NextEra Energy Canada, ULC

Addendum to the Turbine Specifications Report – Bluewater Wind Energy Centre

March, 2013

Figure 2-1 illustrates the modified project location.

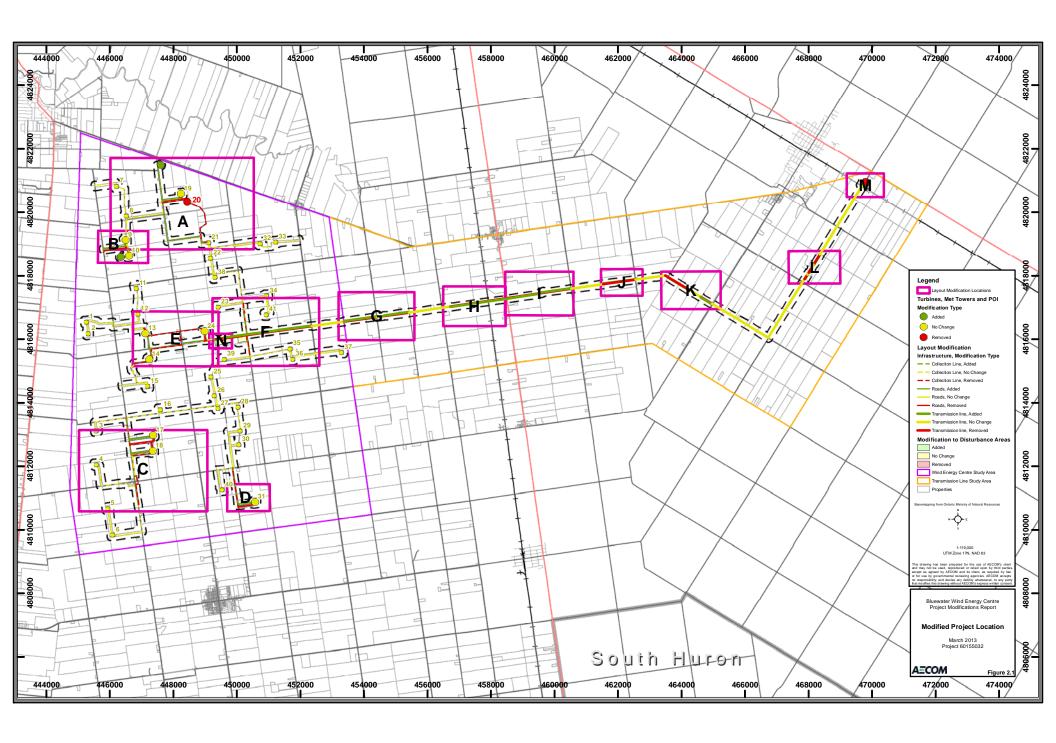
NextEra is proposing modifications to the Project. These proposed Project modifications are summarized in Table 2-1 and Figure 2-1.

Label on Figure 2-1	Proposed Modification	Rationale for Proposed Modification	New Potential Environmental Effects	New Mitigation Measures
A	A1: Removal of Turbine 20 and associated access road and collection line, and provision of new access road to Turbine 19	Land owner no longer participating in project.	None – no new natural heritage or water body features within 120 m; area previously studied for cultural heritage.	N/A
	Addition of meteorological (met) tower and associated infrastructure on private property	The met tower is required to obtain critical data to ensure the safe and efficient operation of the Project. As per amendment to O.Reg. 359/09, met towers are now considered to be part of a renewable energy generation facility and therefore this tower was added to the assessment.	None – no new natural heritage or water body features within 120 m; area previously studied for cultural heritage.	N/A

Relocation of collection line to Turbine 19 (from Turbine 21) – to travel west on north side of private property and north in the Goshen Line right-of-way	Relocation of the collection line is necessary following the removal of Turbine 20.	Cultural Heritage: • Locations 33 and 34 documented.	Cultural Heritage: • Stage 3 assessment of Locations 33 and 34.
В	Relocation of access road to Turbine 9 – to be	As per land owner request for relocation of access road. Minimize impacts to current land use and agricultural practices.	None – no new natural heritage or water body features within 120 m; area previously studied for cultural heritage.	N/A
	Addition of met tower and associated	The met tower is required to obtain critical data to ensure the safe and efficient operation of the Project. As per amendment to O.Reg. 359/09, met towers are now considered to be part of a renewable energy generation facility and therefore this tower was added to the assessment.	None – no new natural heritage or water body features within 120 m; area previously studied for cultural heritage.	N/A

С	Realignment of access road and collection line	As per land owner request for separate access road. Minimize impacts to current land use and agricultural practices.	None – no new natural heritage or water body features within 120 m; area previously studied for cultural heritage.	N/A
	C2: Addition of crane path between Turbines 17 and 18 (located primarily within footprint of infrastructure that is being removed)	Proposed to reduce cost of construction	None – no new natural heritage or water body features within 120 m; area previously studied for cultural heritage.	N/A
	Realignment of access road and collection line to Turbine 18 – to travel directly back from Bronson Line	As per land owner request for separate access road. Minimize impacts to current land use and agricultural practices. Land owner no longer participating in project.	 Natural Heritage: Access road proposed within 120 m of natural area 450. Feature previously studied; identified as Significant Woodland (Woodland E) and Generalized Candidate Significant Wildlife Habitat (Amphibian Woodland Breeding Habitat and Habitat for Species of Conservation Concern). Feature treated as Significant Amphibian Woodland Breeding Habitat (AWO-12) with commitment to complete pre-construction evaluation of significance studies. New potential effects associated with access road construction near this feature include: Accidental intrusion into natural feature resulting in habitat damage; Disruption of amphibians moving to breeding pools and home range; Possible indirect effects on breeding pool condition through changes to surface water drainage patterns resulting from access road construction; and Risk of mortality to amphibians moving between breeding pools and home range due to vehicular collisions along access road None – no new natural heritage or water body features within 120 m; area previously 	Natural Heritage: For Amphibian Woodland Breeding Habitat AWO-12 (if determined to be significant), mitigation measures will be the same as described in the approved NHA for other access roads proposed near amphibian woodland breeding habitat features (Section 5.4).

Realignment of collection line at Bronson Line / Kippen Road to follow Bronson Line right of way	Land owner no longer participating in project.	studied for cultural heritage.	IVA
D	travel directly back from Blind Line	As per land owner request for realignment of access road. Minimize impacts to current land use and agricultural practices.	None – no new natural heritage or water body features within 120 m; area previously studied for cultural heritage.	N/A

Label on Figure 2-1	Proposed Modification	Rationale for Proposed Modification	New Potential Environmental Effects	New Mitigation Measures
E	Realignment of collection line between Turbines 13, 14 and 24	Land owner no longer participating in project	Natural Heritage: Collection line proposed to be installed beneath natural area 487 via directional drilling. Feature previously studied; identified as Significant Woodland (Woodland K), Candidate Significant Amphibian Woodland Breeding Habitat (AWO-06), and Generalized Candidate Significant Wildlife Habitat (Bat Maternity Colony, Mature Forest Stand, and Habitat for Species of Conservation Concern). New potential environmental effects associated with collection line installation under these features: Potential for unplanned intrusion into Significant Woodland Feature K in event of equipment malfunction due to installation of collection line via horizontal directional drilling; and Potential for unplanned intrusion into Significant Amphibian Woodland Breeding Habitat (AWO-06) and Generalized Candidate Significant Wildlife Habitat in natural area 487 in the event of equipment malfunction due to installation of collection line via horizontal directional drilling.	Natural Heritage: • For Significant Woodland K, Amphibian Woodland Breeding Habitat AWO-06 (if determined to be significant) and Generalized Candidate Significant Wildlife Habitat in natural area 487, additional mitigation measures included in the EIS that are the same as described in the approved NHA for collection line installation via directional drilling beneath other Significant Woodlands (Section 5.5) and Generalized Candidate Significant Wildlife Habitat (Section 5.3.2.1).

F	Relocation of transmission line from municipal	Landowner has agreed to participate in project.	None – no new natural heritage or water body features within 120 m; area previously studied for cultural heritage.	
	right-of-way onto private property F2: Relocation of transmission line from municipal right-of-way onto private property	Avoid conflicts with existing infrastructure in the right-of-way. Landowner has agreed to participate in project. Avoid conflicts with existing infrastructure in the right-of-way.	 Natural Heritage: Transmission line is proposed within natural area 514 (vegetation removal required). New site investigation and evaluation of significance studies completed; feature confirmed to be a Significant Woodland (Woodland AJ) and treated as a Significant Bat Maternity Colony (BMC-15) with commitment to complete preconstruction evaluation of significance studies. New potential effects associated with tree removal in these features include: Loss of up to 0.1 ha of forest cover in Significant Woodland Feature AJ; Clearing of vegetation for maintenance of the transmission line, resulting in accidental damage to Significant Woodland AJ; Displacement and/or mortality of nursing female and juvenile bats resulting from vegetation clearing for transmission line construction within Bat Maternity Colony BMC-15; Removal of confirmed significant cavity trees or other suitable cavity trees resulting from vegetation clearing for the transmission line within Bat Maternity Colony BMC-15; and Noise disturbance to and/or avoidance behaviour of bats during construction within Bat Maternity Colony BMC-15. 	 Natural Heritage: Establish an area of forest equal in area to the cleared area through tree planting and management (e.g., in partnership with a local Conservation Authority). Details of the afforestation plan will be provided to MNR in a Compensation Plan. Perform vegetation clearing for construction outside of the breeding bird season and bat maternal period (May 1 to July 31). If this is not possible, MNR will be consulted regarding mitigation measures that may be required. Clearly stake area to be cleared. Fell trees with a chainsaw toward the construction area to reduce damage to adjacent vegetation being retained. Damaged tree roots will be cut clean as soon as possible and exposed roots covered in approved topsoil. This work to be carried out under supervision of an Arborist or Forester. Prepare a tree preservation plan which identifies specific trees to be removed and whether each tree contains a cavity suitable for potential use as a bat maternity colony. For each suitable cavity tree to be removed, a bat house will be installed in the closest suitable woodland habitat (the remainder of the woodland for the affected habitat). Details will be determined through consultation with MNR. Tree removal will occur during daylight hours. Schedule vegetation clearing for operational maintenance to occur outside of the breeding bird season (May 1 to July 31). Undertake active nest surveys if vegetation removal must take place during this period.

Relocation of transmission line from municipal	Landowner has agreed to participate in project. Avoid conflicts with existing infrastructure in the right-of-way.	None – no new natural heritage or water body features within 120 m; area previously studied for cultural heritage.	N/A

Label on Figure 2-1	Proposed Modification	Rationale for Proposed Modification	New Potential Environmental Effects	New Mitigation Measures
G	G1: Relocation of transmission line from municipal right-of-way onto private property	Landowner has agreed to participate in project. Avoid conflicts with existing infrastructure in the right-of-way.	None – no new natural heritage or water body features within 120 m; area previously studied for cultural heritage.	N/A
	G2: Relocation of transmission line from municipal right-of-way onto private property	Landowner has agreed to participate in project. Avoid conflicts with existing infrastructure in the right-of-way.	Water Bodies: • No effects provided that transmission poles are set back 10-15 m from top of bank.	N/A
	G3: Relocation of transmission line from municipal right-of-way onto private property	Landowner has agreed to participate in project. Avoid conflicts with existing infrastructure in the right-of-way.	None – no new natural heritage or water body features within 120 m; area previously studied for cultural heritage.	N/A

Н	Relocation of transmission line from municipal right-of-way onto private property	Landowner has agreed to participate in project. Avoid conflicts with existing infrastructure in the right-of-way.	None – no new natural heritage or water body features within 120 m; area previously studied for cultural heritage.	N/A
ı	I1: Relocation of transmission line from municipal right-of-way onto private property	Landowner has agreed to participate in project. Avoid conflicts with existing infrastructure in the right-of-way.	Natural Heritage: None – no new natural heritage features within 120 m. Water Bodies:	N/A
	I2: Relocation of transmission line from municipal right-of-way onto private property	Landowner has agreed to participate in project. Avoid conflicts with existing infrastructure in the right-of-way.		 (May 1 to July 31). If this is not possible: maintain a 20 m buffer around any active Red-headed Woodpecker nest within which no vegetation removal will occur; and MNR will be consulted regarding mitigation measures that may be required. Clearly stake area to be cleared.

J	J1: Relocation of transmission line from municipal right-of-way onto private property	Avoid conflicts with existing infrastructure in the right-of-way. Avoid conflicts with existing infrastructure in the right-of-way.	 Transmission line is proposed within natural area 555. New site investigation and evaluation of significance studies completed; feature confirmed to be a Significant Woodland (Woodland AP). New potential effects associated with tree removal in this feature include: Loss of up to 0.2 ha of forest cover in Significant Woodland Feature AP; and Clearing of vegetation for maintenance of the transmission line, resulting in accidental damage to Significant Woodland AP. Cultural Heritage: Location 29 documented. 	 Natural Heritage: Establish an area of forest equal in area to the cleared area through tree planting and management (e.g., in partnership with a local Conservation Authority). Details of the afforestation plan will be provided to MNR in a Compensation Plan. Perform vegetation clearing for construction outside of the breeding bird season (May 1 to July 31). If this is not possible, MNR will be consulted regarding mitigation measures that may be required. Clearly stake area to be cleared. Fell trees with a chainsaw toward the construction area to reduce damage to adjacent vegetation being retained. Damaged tree roots will be cut clean as soon as possible and exposed roots covered in approved topsoil. This work to be carried out under supervision of an Arborist or Forester. Schedule vegetation clearing for operational maintenance to occur outside of the breeding bird season (May 1 to July 31). Undertake active nest surveys if vegetation removal must take place during this period. Cultural Heritage: Stage 3 assessment of Location 29. Natural Heritage:

Relocation of transmission line from municipal right-of-way to follow unopened municipal right-of-way	Avoid conflicts with existing infrastructure in the right-of-way.	 Natural Heritage: Transmission line is proposed within natural area 582. New site investigation and evaluation of significance studies completed; not a significant feature. Water Bodies: No effects provided that transmission poles are set back 10-15 m from top of bank. 	•

Label on Figure 2-1	Proposed Modification	Rationale for Proposed Modification	New Potential Environmental Effects	New Mitigation Measures
К	Relocation of transmission line from municipal		None – no new natural heritage or water body features within 120 m. Area subsequently studied for cultural heritage – no new resources affected.	N/A
	Relocation of transmission line from municipal	Landowner has agreed to participate in project. Avoid conflicts with existing infrastructure in the right-of-way.	Water Bodies: No effects provided that transmission poles are set back 10-15 m from top of bank.	N/A
	Relocation of transmission line from municipal		None – no new natural heritage or water body features within 120 m; area previously studied for cultural heritage.	N/A
L	Relocation of transmission line from municipal right-of-way onto private property	Landowner has agreed to participate in project. Avoid conflicts with existing infrastructure in the right-of-way.	Water Bodies: No effects provided that transmission poles are set back 10-15 m from top of bank.	N/A

M	Seaforth substation property to private property		None – no new natural heritage or water body features within 120 m; area previously studied for cultural heritage.	N/A
N	Relocation of substation within the same property parcel	,	None – no new natural heritage or water body features within 120 m; area previously studied for cultural heritage.	N/A
